SANTA FE COUNTY
IFB NO. 2019-0138-PW/KE
CONSTRUCTION PHASE III IMPROVEMENTS AT
POJOAQUE VALLEY RECREATION COMPLEX
ADDENDUM #1

Changes to the Drawings

PHASE 1 AND 2 ELECTRICAL SITE LIGHTING PLAN

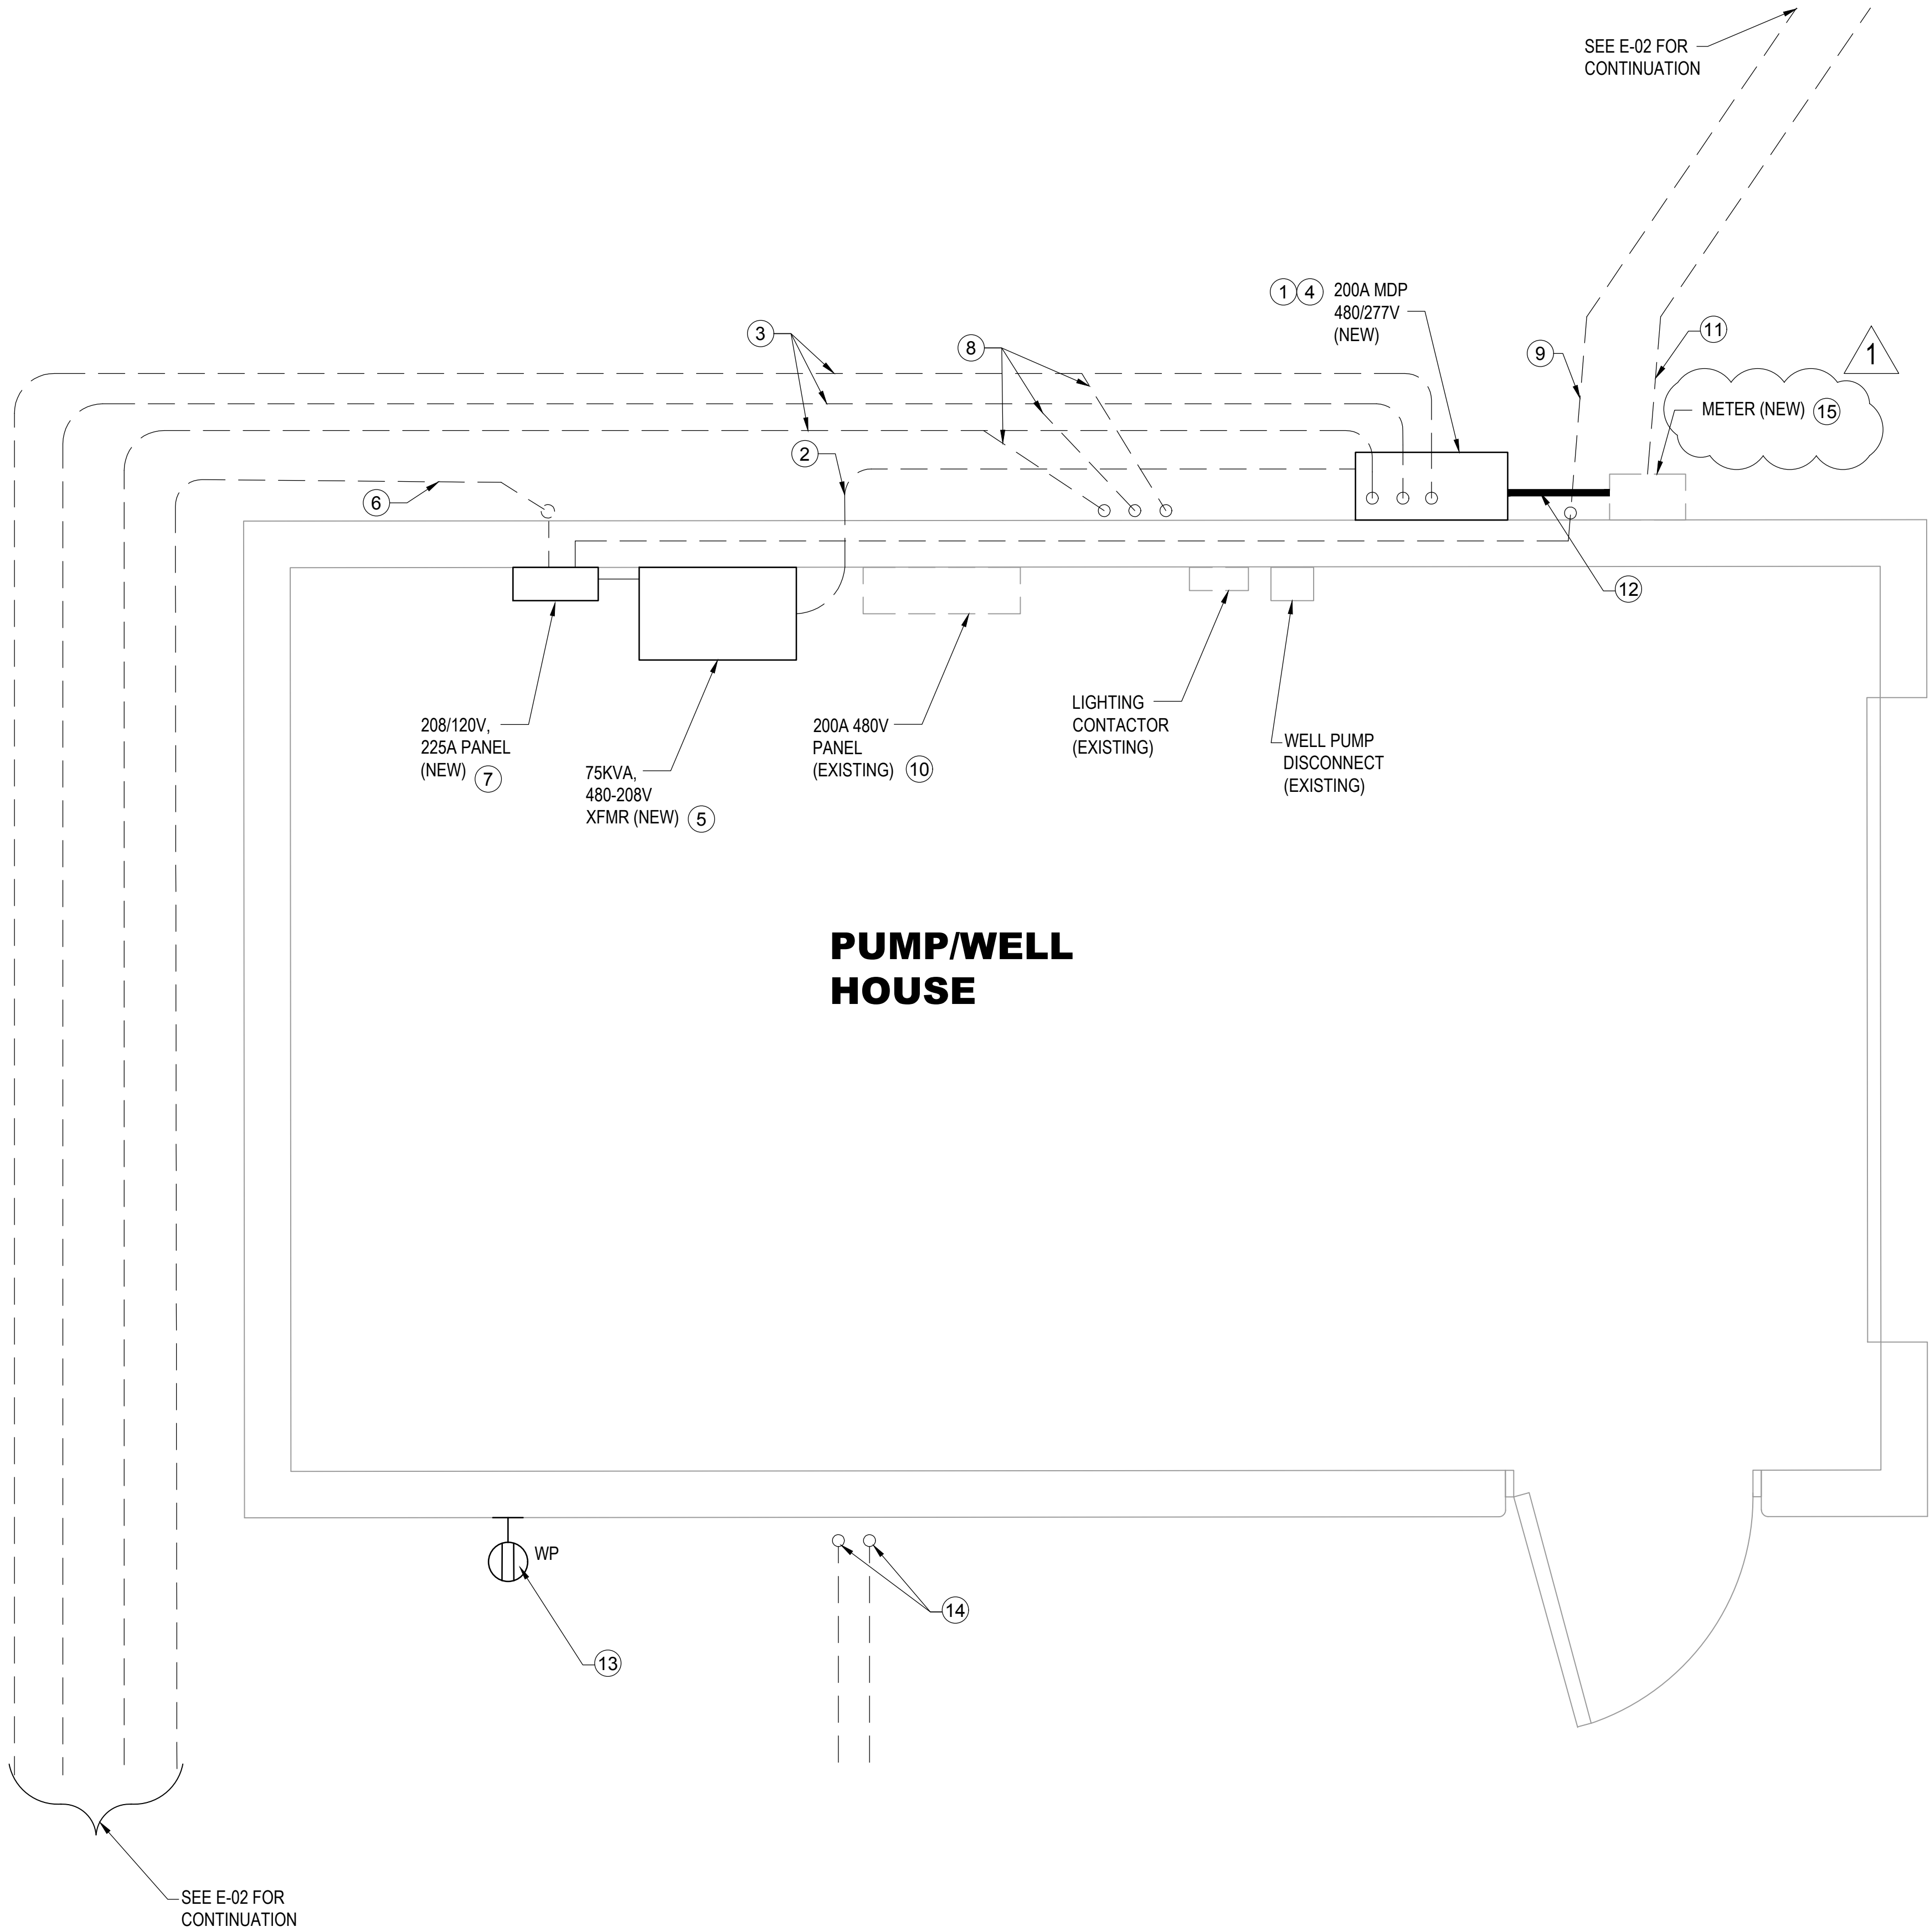
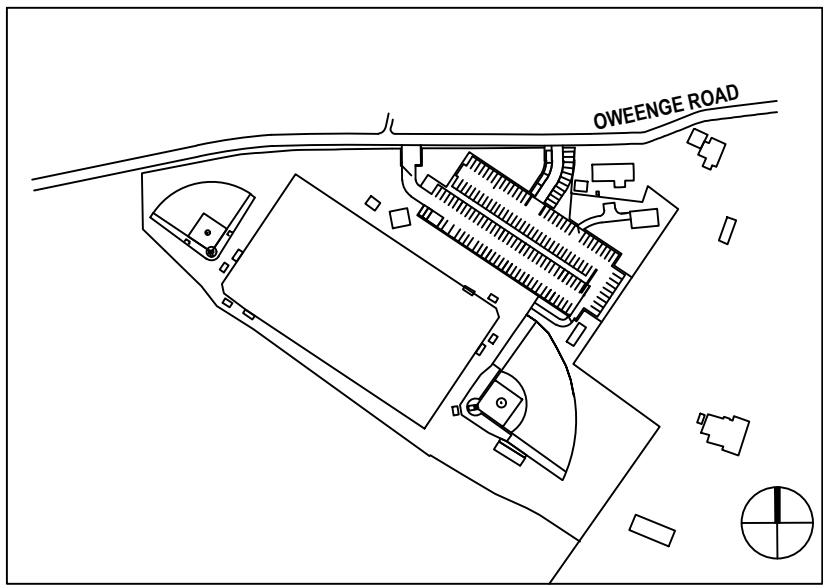
1. E-02 Electrical Site Plan, Revisions to note 9/E-02:

REVISE Keyed Note 9: NEW UTILITY POLE LOCATION. COORDINATE WITH UTILITY TO ADD NEW POLE AND REMOVE POLES DOWN STREAM. REPLACE POLE TOP TRANSFORMER WITH NEW POLE TOP TRANSFORMER TO MATCH THE EXISTING 37.5KVA UTILITY TRANSFORMER. CONNECT TO ~~NEW EXISTING~~ METER BELOW GRADE VIA 4" BURIED CONDUIT **36"** 24" BELOW GRADE MINIMUM. **INSTALL RIDGID ELBOWS AT RISER TRANSITIONS FROM BELOW GRADE.**

- NEW UTILITY POLE LOCATION. COORDINATE WITH UTILITY TO ADD NEW POLE AND REMOVE POLES DOWN STREAM. REPLACE POLE TOP TRANSFORMER WITH NEW POLE TOP TRANSFORMER TO MATCH THE EXISTING 37.5KVA UTILITY TRANSFORMER. CONNECT TO NEW METER BELOW GRADE VIA 4" BURIED CONDUIT 36" BELOW GRADE MINIMUM. INSTALL RIDGID ELBOWS AT RISER TRANSITIONS FROM BELOW GRADE.

E-04

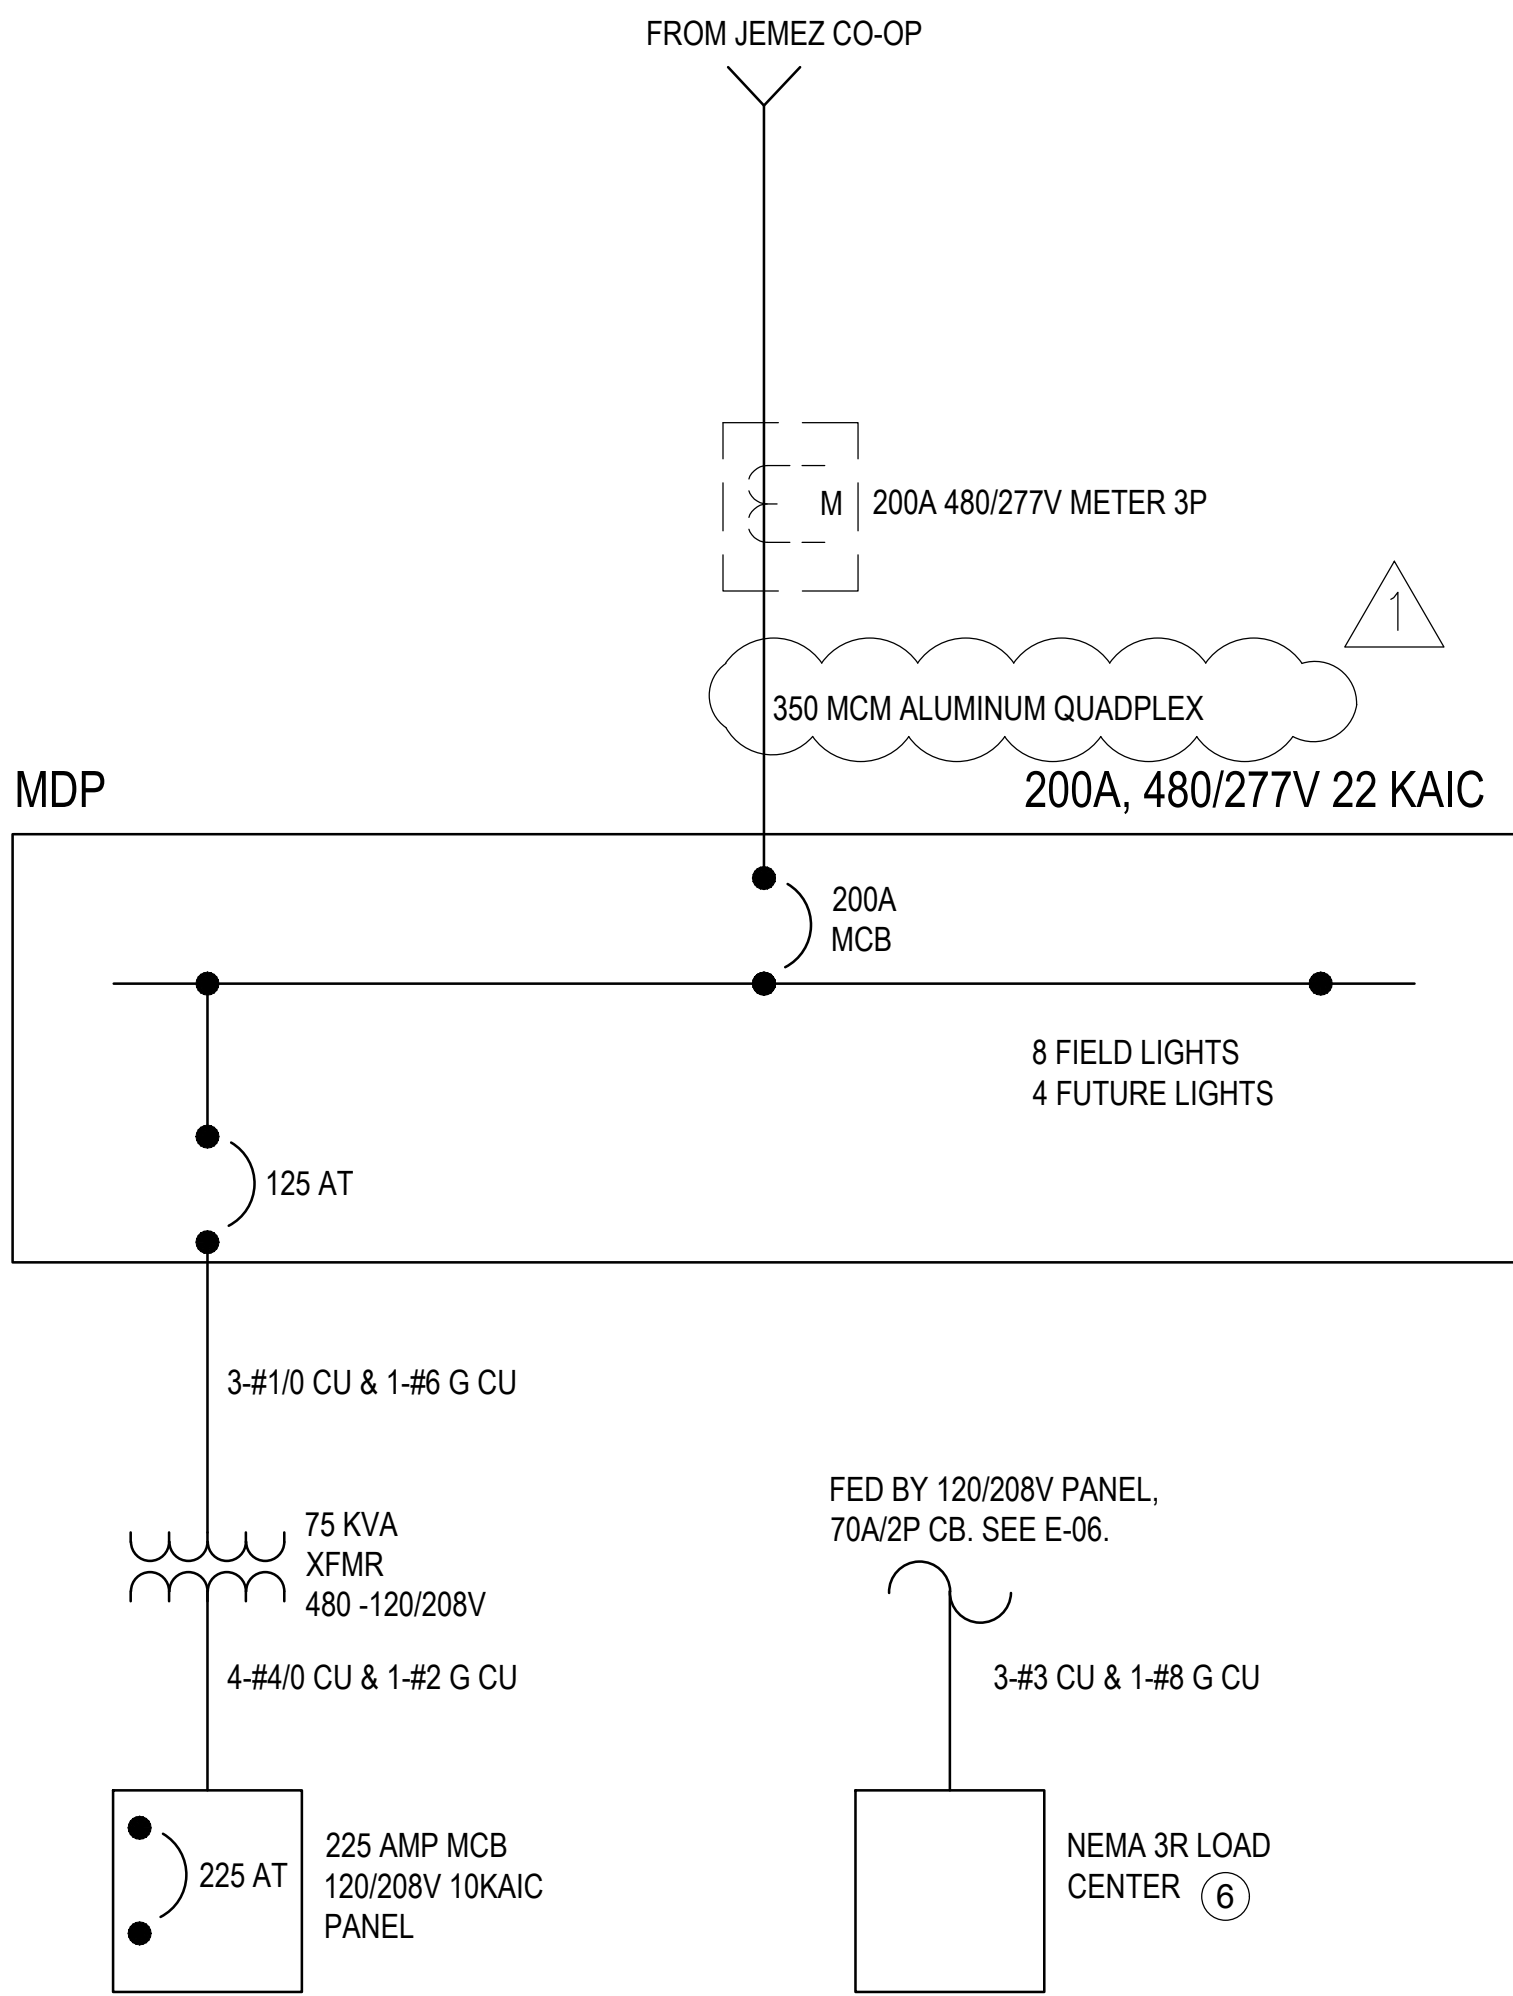
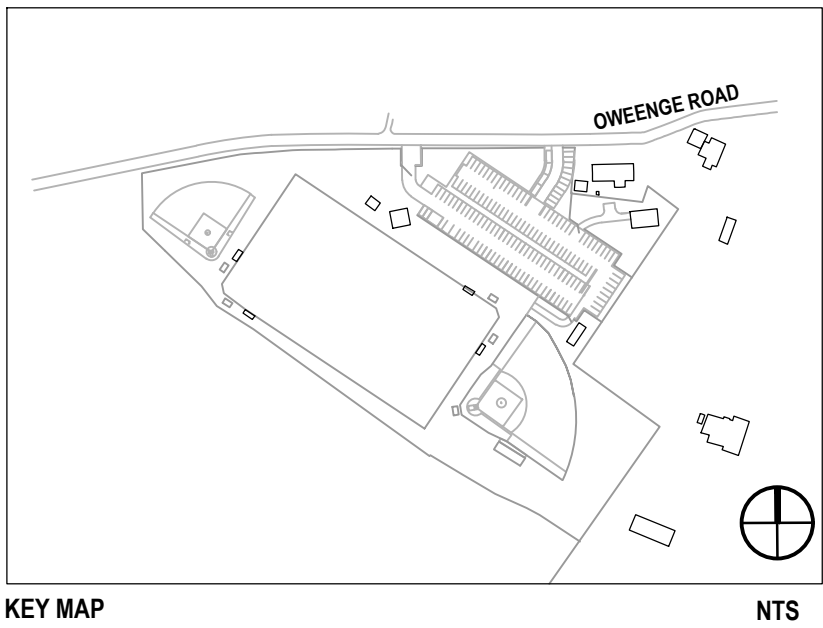
2. E-04 Electrical Power Plan, Revisions to note 11/E-04, New note 15/E-04:

REVISE Keyed Note 11: INSTALL 4" SCHEDULE 40 PVC CONDUIT FOR NEW UNDERGROUND FEED TO THE NEW POLE MOUNTED TRANSFORMER. CONDUIT TO BE INSTALLED AT A MINIMUM OF **36"** 24" BELOW GRADE. **INSTALL RIDGID ELBOWS AT RISER TRANSITIONS FROM BELOW GRADE.**

ADD Keyed Note 15: **PROVIDE A NEW METER BASE FOR NEW ELECTRICAL METER. METER BASE SHALL ADHERE TO JMEC ELECTRICAL STANDARDS, 3-PHASE, 7 JAW, SELF-CONTAINED.**

- INSTALL 4" SCHEDULE 40 PVC CONDUIT FOR NEW UNDERGROUND FEED TO THE NEW POLE MOUNTED TRANSFORMER. CONDUIT TO BE INSTALLED AT A MINIMUM OF 36" BELOW GRADE. INSTALL RIDGID ELBOWS AT RISER TRANSITIONS FROM BELOW GRADE.

- PROVIDE A NEW METER BASE FOR NEW ELECTRICAL METER. METER BASE SHALL ADHERE TO JMEC ELECTRICAL STANDARDS, 3-PHASE, 7 JAW, SELF-CONTAINED.

E-06

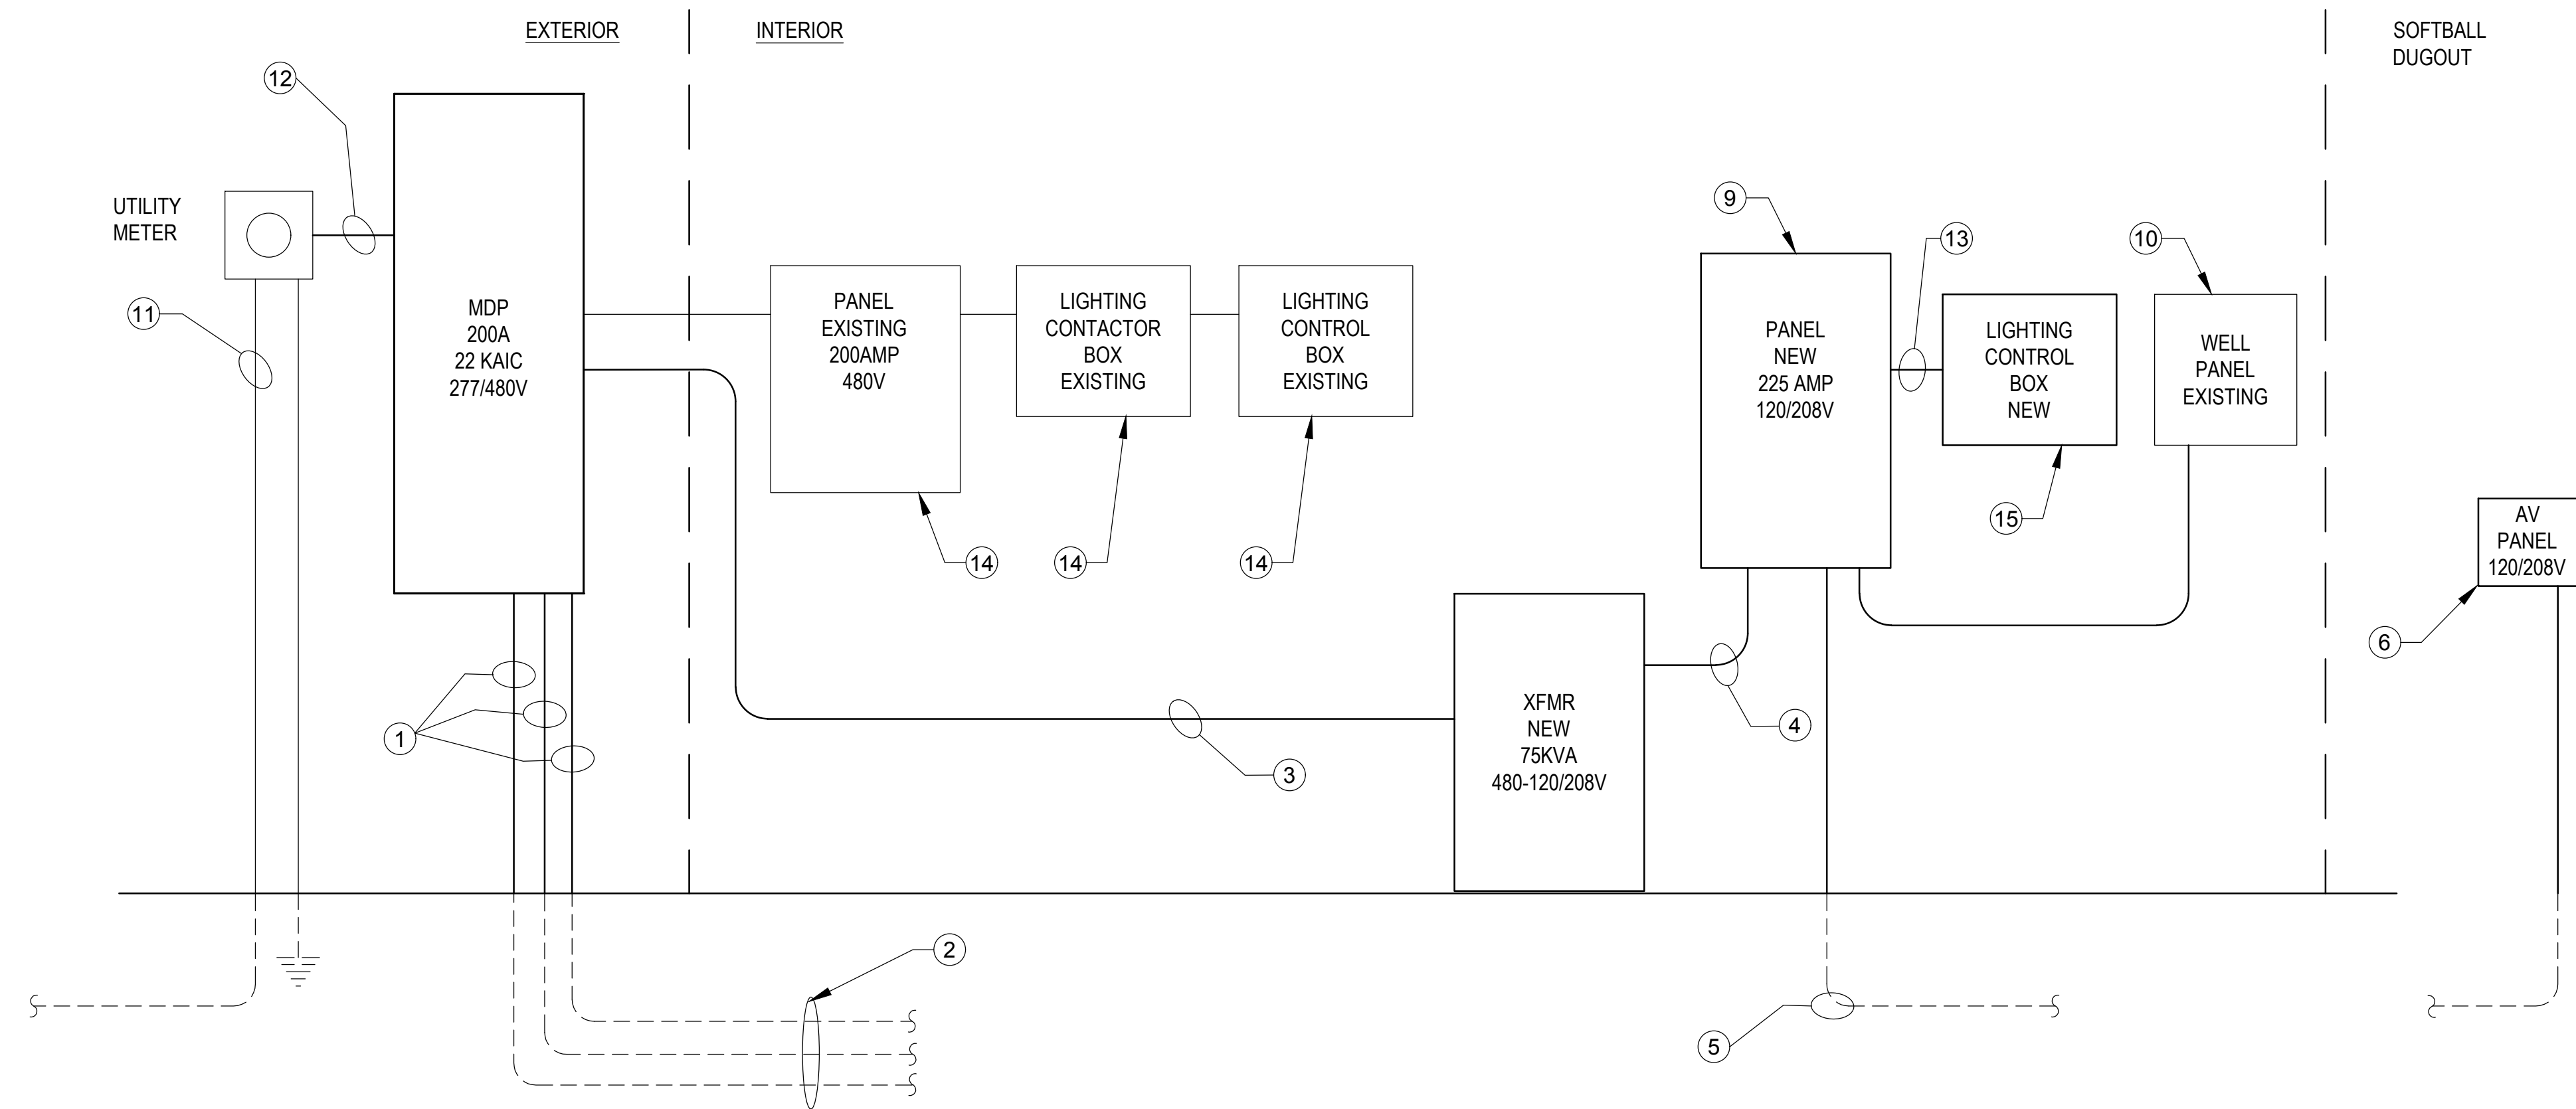
3. E-06 Electrical Power Diagrams, Revisions to note 11/E-06:

REVISE Keyed Note 11: INSTALL (1) 4" SCHEDULE 40 PVC CONDUIT FROM NEW POLE MOUNTED TRANSFORMER TO REFEED ~~NEW EXISTING~~ METER.

- REFEED PUMP CONTROLLER TO NEW 120/208V PANEL.
- INSTALL (1) 4" SCHEDULE 40 PVC CONDUIT FROM NEW POLE MOUNTED TRANSFORMER TO FEED NEW METER.
- INSTALL 4" RIDGID METAL CONDUIT.
